Minutes of the Mandatory Site Meeting

**Request for Proposals ES-24-04
Cell Two Grubbing and Grinding - FBRL**

**Thursday, March 14, 2024
1:30 p.m. at the Foothills Boulevard Regional Landfill**

Regional District of Fraser-Fort George
 Foothills Boulevard
 Prince George, BC
 Date of Photo: October 26, 2023

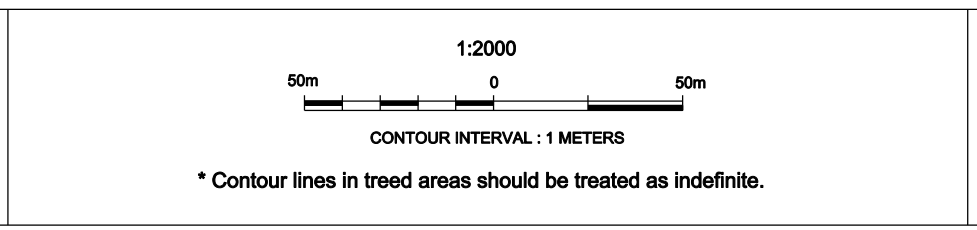
Question: Has a survey ever been completed?

Contour Map attached – take a look at the Northwest corner of this area as it will not be marked on the map

Answer: The Regional District will provide a contour map of the area, keep in mind it shows the area prior to the most recent logging. (see attached to these notes)
